UNITED STATES PATENT AND TRADEMARK OFFICE

APPLICATION NO.	FILING DATE	FIRST NAMED INVENTOR	ATTORNEY DOCKET NO.	CONFIRMATION NO.
10/699,389	10/31/2003	Chung Cheung	HKPC/370/US	3269
2543	7590	08/25/2005	EXAMINER	
ALIX YALE & RISTAS LLP 750 MAIN STREET SUITE 1400 HARTFORD, CT 06103			LANGDON, EVAN H	
			ART UNIT	PAPER NUMBER
			3654

Office Action Summary	Application No. 10/699,389	Applicant(s) CHEUNG, CHUNG	
	Examiner Evan H. Langdon	Art Unit 3654

DETAILED ACTION

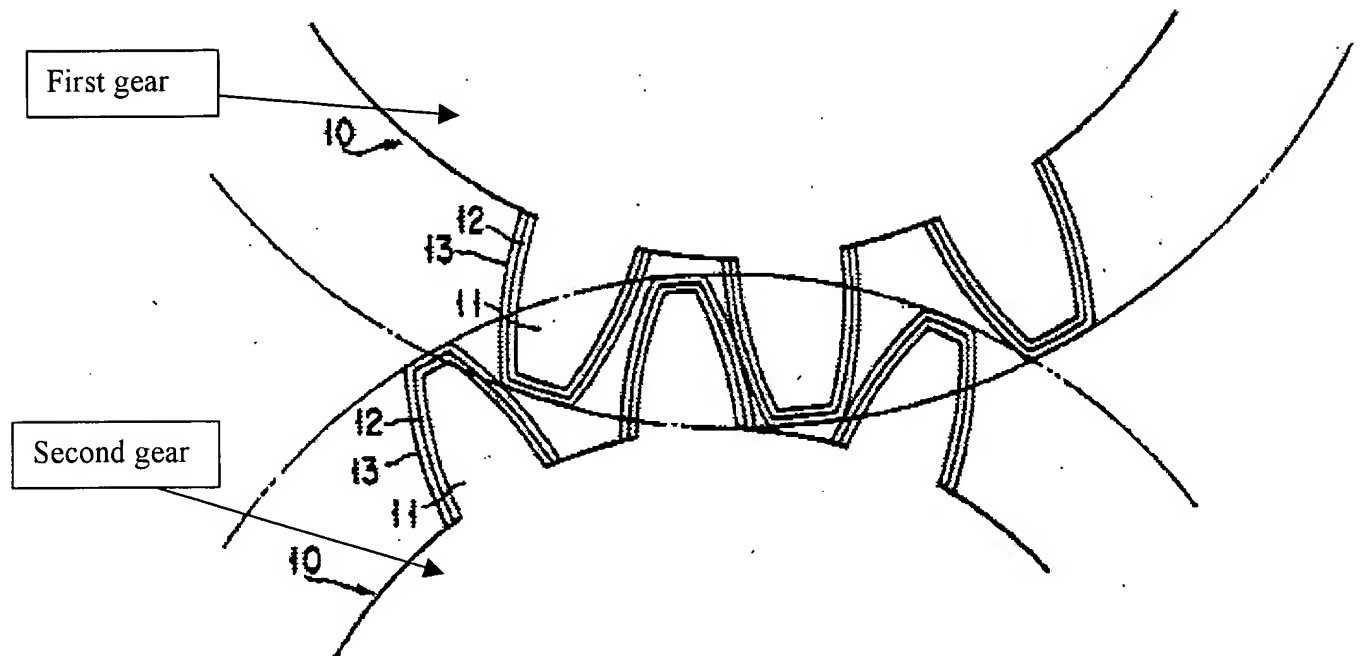
In regards to claim 1 and 12, Honda discloses a gear couple comprising:

a first gear 10 having a first meshing base, the first meshing base being covered by a first layer 13 which includes the element gold (col. 2, line 36) disposed substantially uniformly over the meshing base;

a second gear 10 (see below) having a second meshing base, the second meshing base being covered by a second layer which includes the element chromium 12 (col. 2, line 65-67) disposed substantially uniformly over the meshing base,

wherein the first layer and the second layer engage in meshing contact.
